PAD: 16-143970-LK & 16-145946-LO

PROJECT: Park Pointe PUD

Description: Application for Land Use approval for a Planned Unit Development (PUD) and Critical Areas Land Use Permit approval for a residential development consisting of 41 single family detached residences on a 12.2 acre site, zoned R-3.5. The site includes steep slope critical areas, wetlands and streams. Coal Creek (Type F stream) borders the southwest portion of the site and there are 3 tributary (Type N) streams on site. There are 2 Category IV and 1 Category III wetlands on the site. Critical areas and open space is proposed to be set aside in a separate tract. Two (2) existing single family residences on the site are proposed to be demolished.

Figure 1. Conceptual mitigation plan

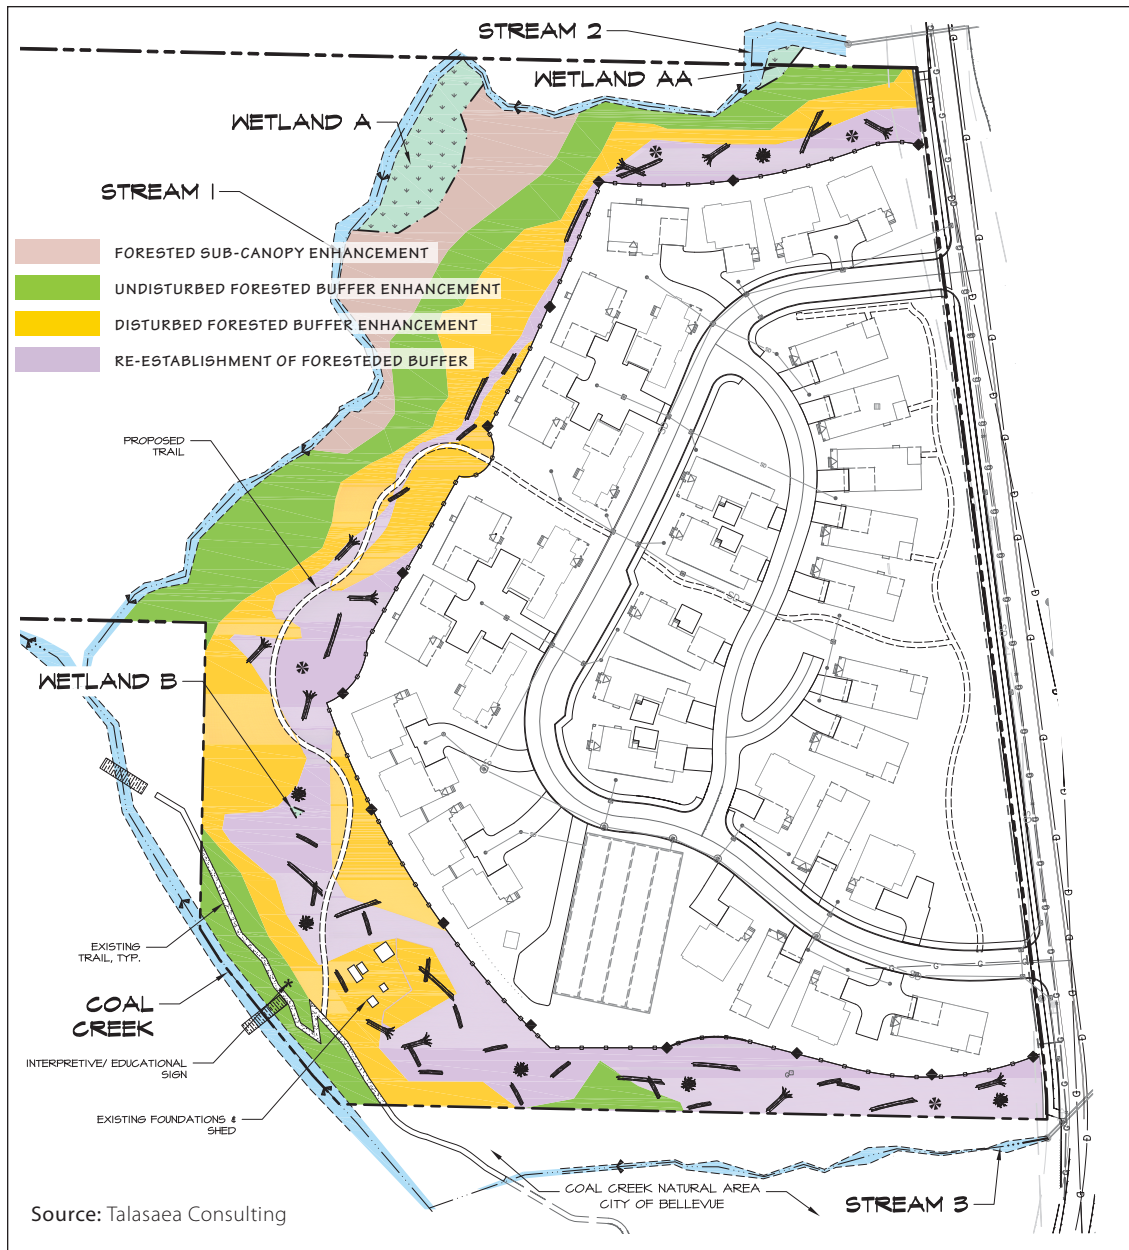
The site contains critical areas including steep slopes, wetlands, streams, and coal mine hazards. The project proposes a combination of several different mitigation measures intended to compensate for buffer functions and values lost through reduced buffer widths, temporary disturbance, and dedication to trails or right-of-way. Mitigation activities will occur on 3.00 acres of the property as outlined in Figure 1 and below:

The proposed mitigation will result in a net gain in critical area functions and values compared to existing conditions. The total mitigation proposed represents a 4.6:1 mitigation-to-impact ratio.

FIGURE 2
Street Requirements

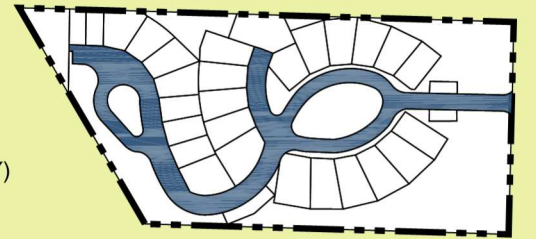
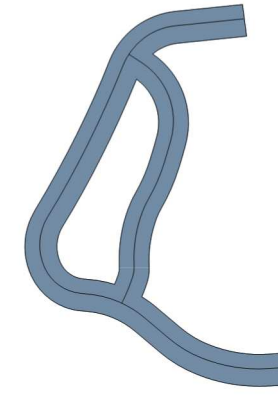
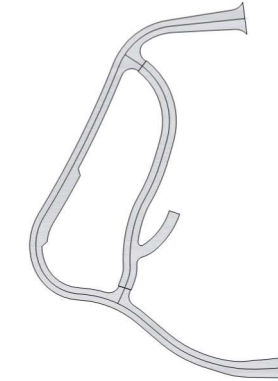
Nowhere is this more evident on Park Pointe than with the proposed road system. Figure 2 illustrates the impact of providing the minimum 47-foot-wide street improvements at Park Pointe. This would negatively impact the PUD proposal by:

- ### Public Streets
- 47 foot width total
 - Traveled way.....24
 - Curb width (2x 6").....1
 - Landscape(2x 5').....10
 - Sidewalk (2x 6').....12
 - ABOVE SECTION IDENTIFIED AS THE MINIMUM ALLOWED PUBLIC STREET IN COMMENT LETTER DATED DECEMBER 12/2/2019.

- ### Proposed Private Streets
- 28 foot width total
 - Traveled way.....20
 - Curb width (2x 6").....1
 - Sidewalk (1x 7').....7
 - Total Width Varies.....21-28

ATTACHMENT 1
Clearing & Grading Review -
Coal Mine Hazard Mapping

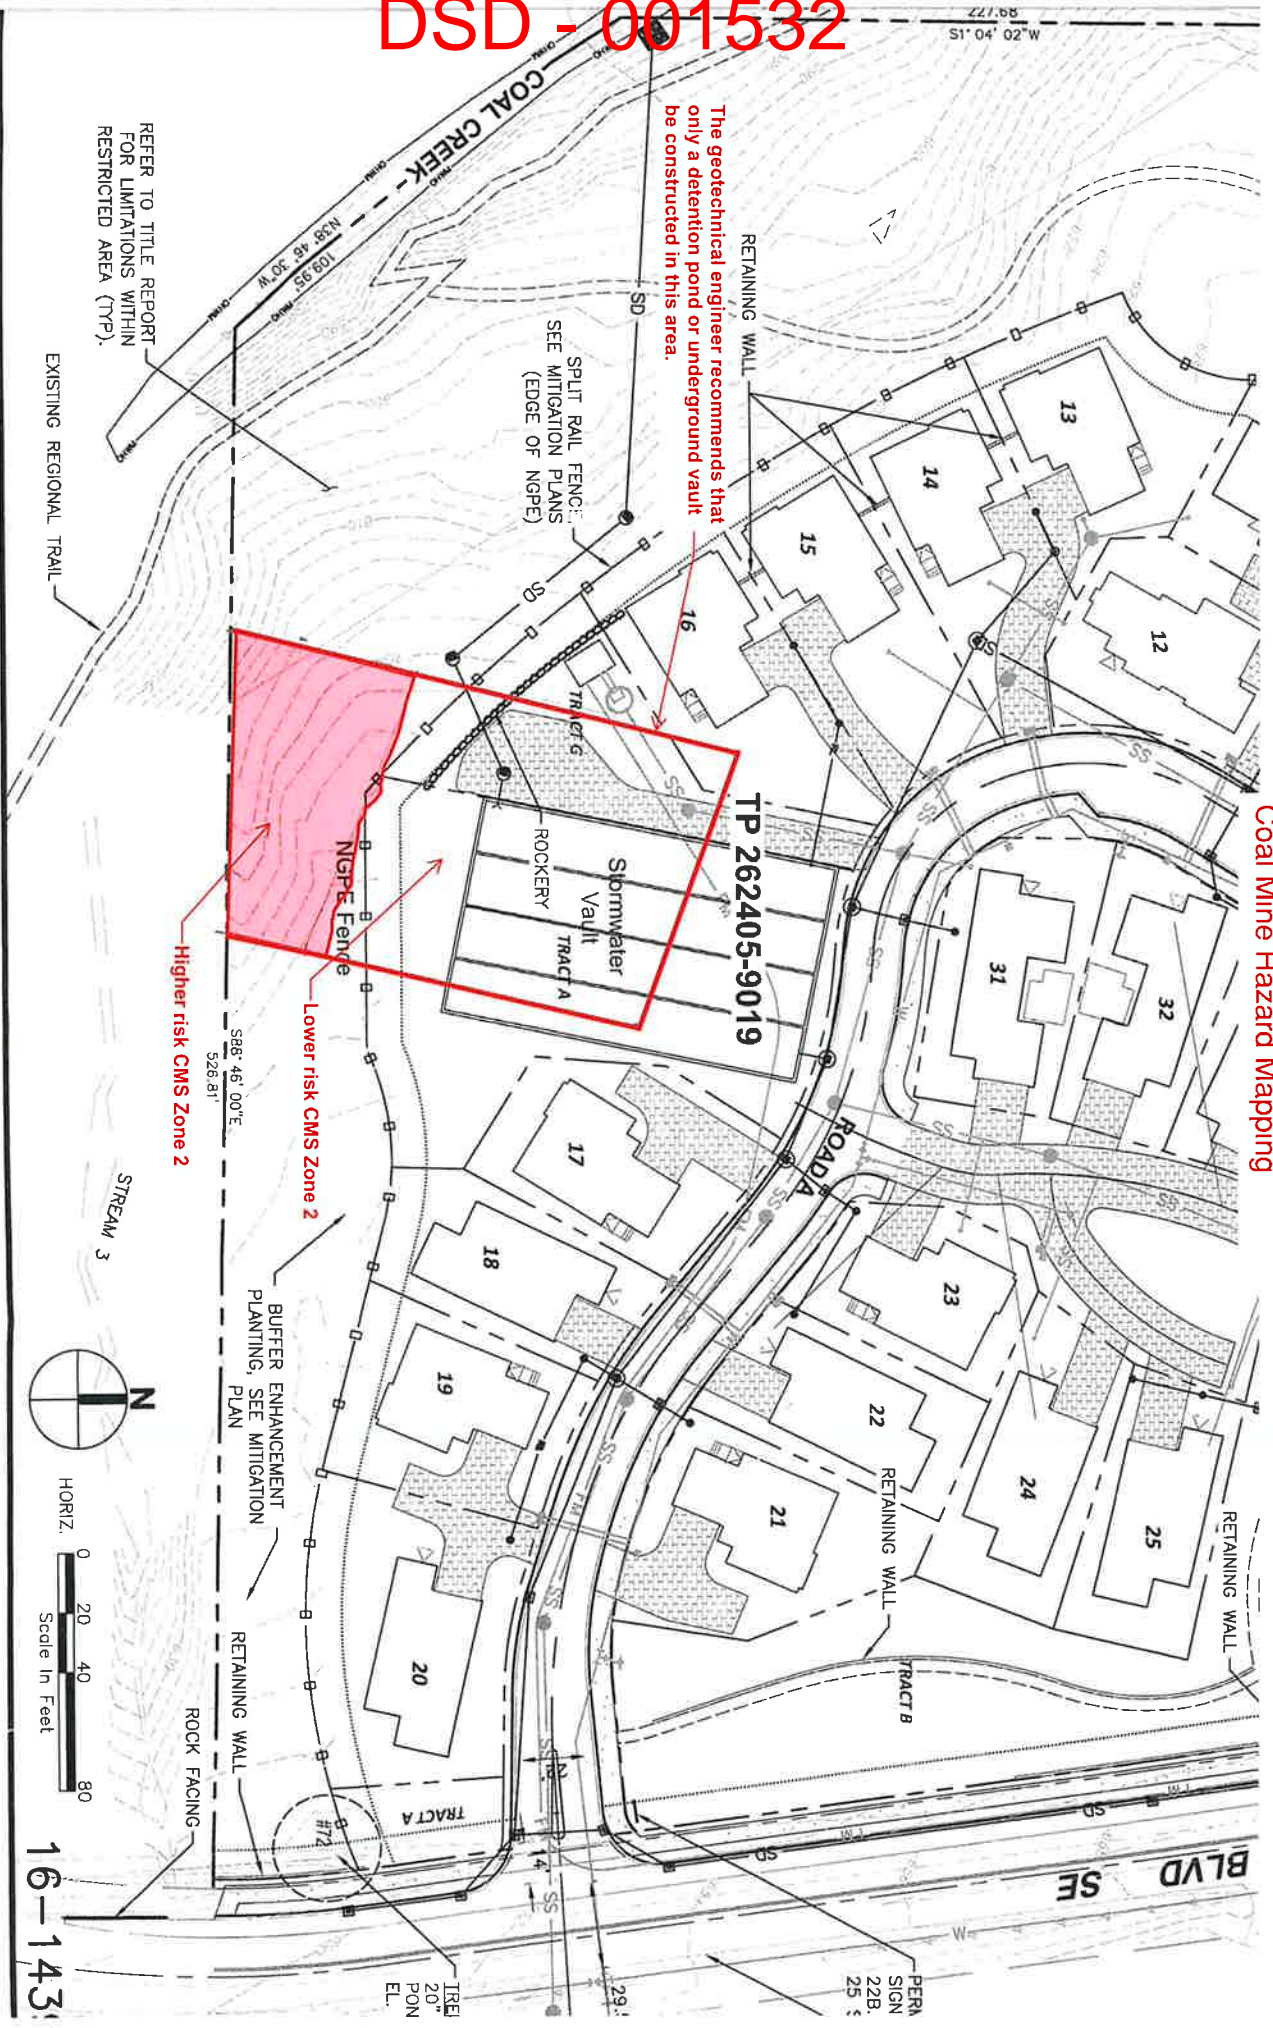
On review of the preliminary plat plans, it was noted that a portion of lot 16 and a section of a sanitary sewer line and a sewer force main extend onto the lower risk CMS Zone 2 (see attached scans of Sheet P2-Base Density Calculation, and P5-Site Plan B). This configuration is contrary to the recommendations in the hazard assessment. No development is shown in the higher risk CMS Zone 2.

Figure
4

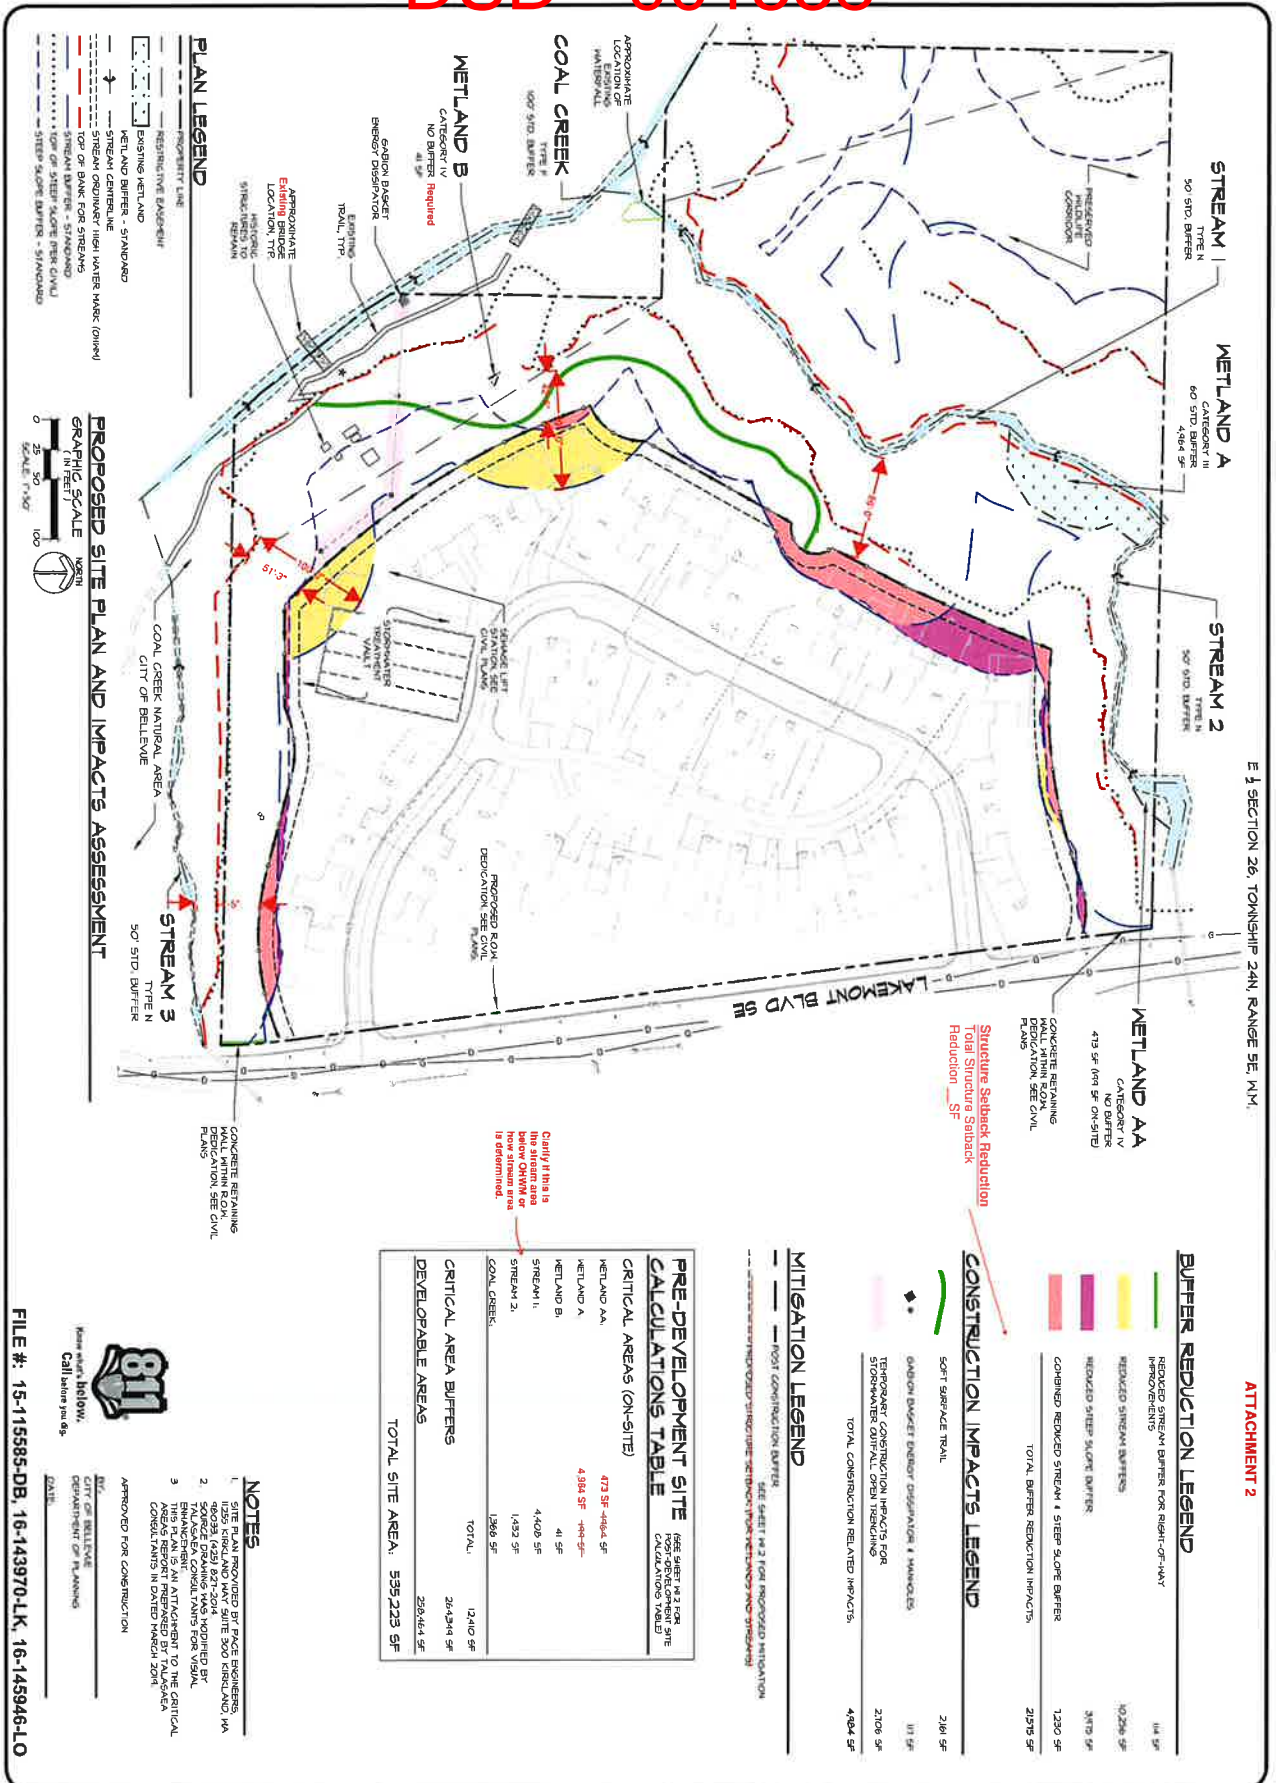
The Revised Coal Mine Hazard Assessment (Icicle Creek Engineers, October 5, 2016) provides results of a ground-proofing study and includes Figure 4 which identifies a higher and lower risk Coal Mine Subsidence (CMS) Zone 2. The report recommends that the stormwater vault can be sited within the lower risk CMS Zone 2, but no development should occur within the higher risk CMS Zone 2 (where the mine shaft is less than 100 feet below the ground surface). Please confirm the proposed site plan is consistent with identified boundaries of the higher risk CMS Zone 2 in Figure 4, and that no development including the stormwater vault, access Road E, or the sewer lift station would encroach into the higher risk CMS Zone 2.

In our opinion, development should be unrestricted with regard to coal mine hazards within the PAOI as shown on Figure 2; we recommend that the PAOI be reclassified as a Declassified Coal Mine Area as shown on Figure 4.

Based on the results of our ground proofing study, we recommend that the 100-foot wide "corridor" referred to as the SAOI (where an inclined mine shaft is located) be classified as a CMS Zone 2, with further classifications as Lower Risk CMS Zone 2 and Higher Risk CMS Zone 2 as shown on Figure 4. The Lower Risk CMS Zone 2 could be used for a stormwater detention pond or underground vault provided that the pond/vault site is maintained within the area where the mine shaft is more than 100 feet below the ground surface as shown on Figure 4. No development should occur within remainder of the SAOI where the mine shaft is less than 100 feet below the ground surface; this area is shown as the Higher Risk CMS Zone 2 on Figure 4.

Peter Rosen

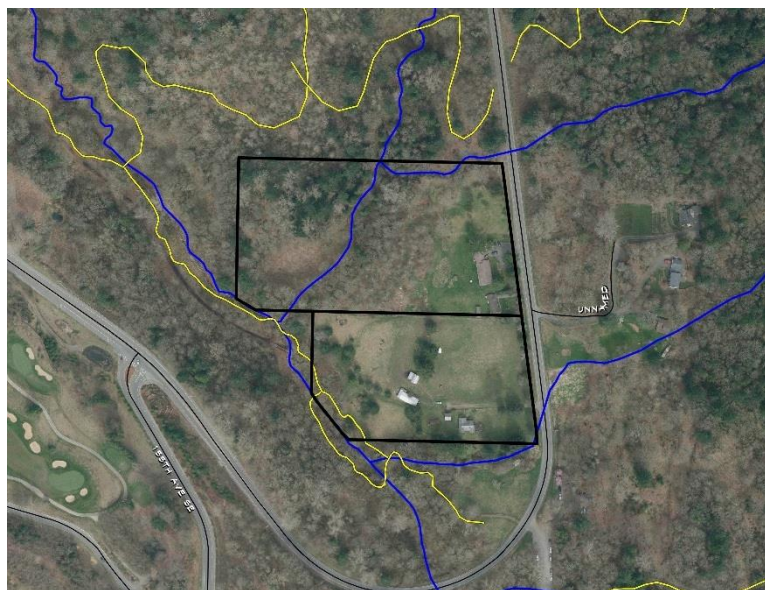
Comment - Habitat Functions - H2.2 Corridors and Connections – Given the location of the wetland adjacent to the stream ravines and the protected natural area of Coal Creek Park, it appears that Wetland A would meet the criteria for H 2.2.2 – that it is *part of a relatively undisturbed and unbroken corridor (either riparian or upland) that is at least 50 ft. wide, has at least 30% cover of shrubs or forest, and connects to estuaries, other wetlands or undisturbed uplands that are at least 25 acres in size.* This would assign 2 additional points. Please clarify and provide additional information.

Applicant Response: We disagree with the proposed changes to Questions H2.1 and H2.2. The key term for both of these questions is “relatively undisturbed.” This is an issue on which we consulted Tom Hruby (formerly of Washington Department of Ecology) for a different project. Disturbance is defined in the 2004 Washington State Wetland Rating System for Western Washington (as revised in 2006). Page 80, Comment 81, Item 3 states that “[b]uffers that are regularly accessible to dogs, either from residential areas or from people walking their dog should be treated as disturbed [sic].” We know that the residents of the two parcels do have dogs that have free run of the mowed areas of the site. We also know that the area surrounding the site (north, west, and south) is City of Bellevue park property with several, well-used hiking trails (see Photo 1). These trails are used on a daily basis. We considered this information in our analysis of what constitutes a relatively undisturbed buffer. Based on the City of Bellevue’s GIS database on trails, we were able to discern that the minimum of 25 acres of “relatively undisturbed” habitat does not exist for any of the onsite wetlands.
